UNITED STATES PATENT AND TRADEMARK OFFICE

APPLICATION NO.	FILING DATE	FIRST NAMED INVENTOR	ATTORNEY DOCKET NO.	CONFIRMATION NO.
09/670,820	09/28/2000	Atsushi Shimonaka	0717-0446P	8768
7590	04/02/2004		EXAMINER	
Birch Stewart Kolasch & Birch LLP P O Box 747 Falls Church, VA 22040-0747			LANDAU, MATTHEW C	
			ART UNIT	PAPER NUMBER
			2815

Office Action Summary	Application No.	Applicant(s)
	09/670,820	SHIMONAKA, ATSUSHI <i>[Signature]</i>
	Examiner	Art Unit
	Matthew Landau	2815

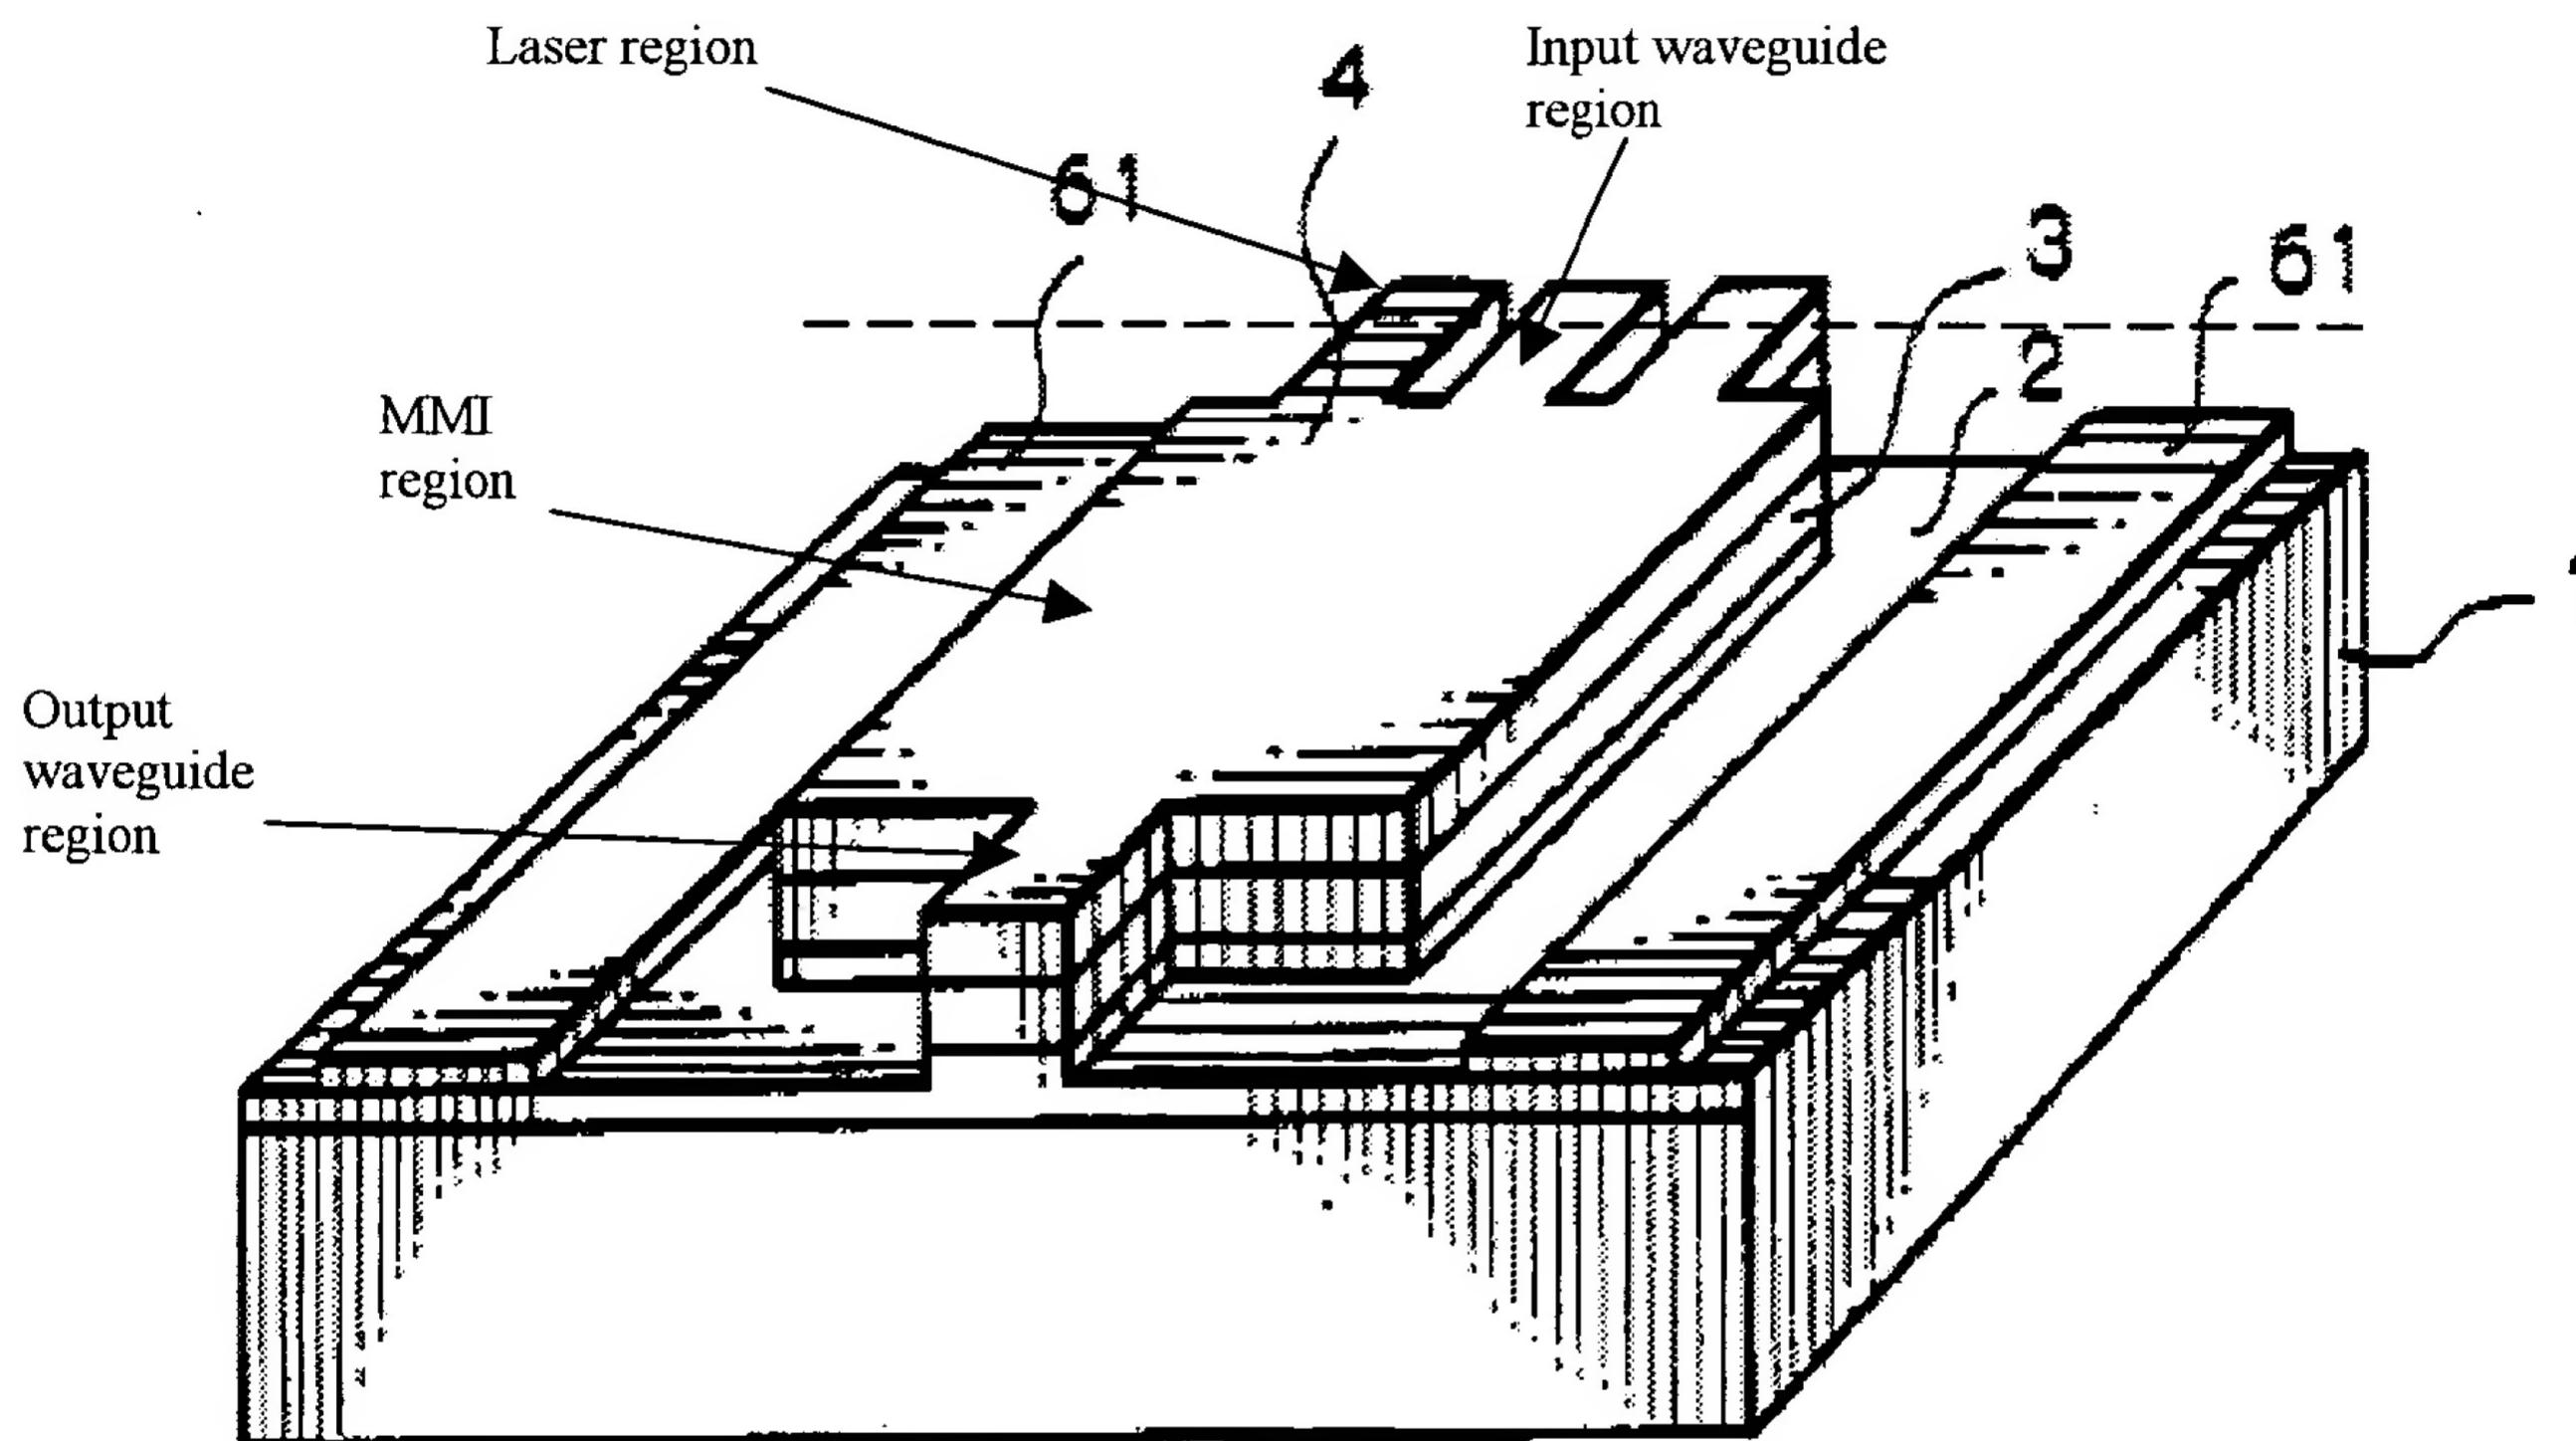
In regards to claim 1, Figures 6 and 8 of Hamamoto disclose a semiconductor laser element, comprising: a semiconductor laser region including a plurality of laser emission portions (the three protruding portions at the top of Figure 6) each having the same construction relative to one another and arranged side by side in a parallel array, each of said laser emission portions including an active layer 3 for emitting light; a multimode interference (MMI) region (middle region) including a first wave guiding layer 3; an input waveguide region located between the semiconductor laser region and the multimode interference region, said input waveguide region including a plurality of wave-guiding portions (the three protruding portions) where all the wave-guiding portions are equal length in an optical direction; and an output waveguide region (single protruding portion at the bottom of Figure 6) including a second wave-guiding layer 3, the second wave-guiding layer being optically coupled to an opposite end of the first wave-guiding layer of the interference region. As can be seen from Figures 4 and 5, Hamamoto discloses that the entire device is made from the same layers. Layer 3 functions as both an active layer and a waveguide layer. Furthermore, an electrode 7 covers all sections. Therefore, the three protruding portions at the top, the MMI region, and the single protruding portion at the bottom can be considered both laser regions and waveguide regions. Applicant has not claimed any structural difference between the laser region (laser emission portions) and the

input waveguide region (wave-guiding portions). Therefore, it is considered by the Examiner that the top halves of the three protruding portions are the laser emission portions while the bottom halves are the wave-guiding portions. The following figure is provided for clarification. The dotted line represents the junction between the laser region and the input waveguide region.

In regards to claim 28, Figures 6 and 8 of Hamamoto disclose a semiconductor laser element comprising: a semiconductor laser region including a plurality of laser oscillation portions (the three protruding portions at the top of Figure 6) each having the same construction relative to one another, arranged side by side, and having a common modulation electrode 7 traversing all of the laser emission portions for operating said laser emission portions in a single mode (col. 2, lines 53-55), each of said laser oscillation portions having an active layer 3 which performs laser operations at a same wavelength (col. 3, lines 10-16); a MMI region (middle region) including a first wave-guiding layer 3 coupled to said laser oscillation portions via an input waveguide region (three protruding portions) including a plurality of parallel equal length waveguides having respective second wave-guiding layers 3 where all the waveguides are equal
